Technical Service Bulletin – 15

Exhaust Heat Wrap

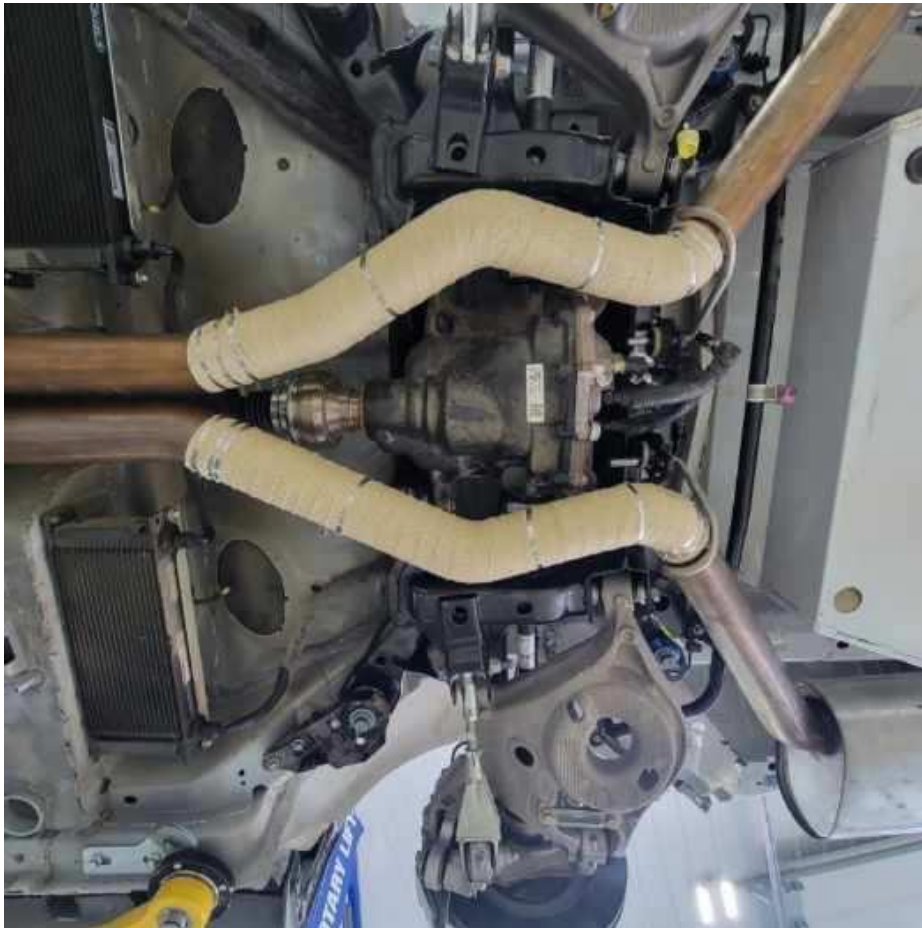
Issue: Excessive exhaust heat can cause degradation of the half shaft boots and grease.

Action: Install heat wrap per the information below.

1. Install wrap as shown from the exhaust bend closest to the differential coolers up to the exhaust hangers located just behind the differential.
2. Use approximately a 50% overlap of the wrap.
3. Use band clamps on both ends. Additional clamps may be used as desired.
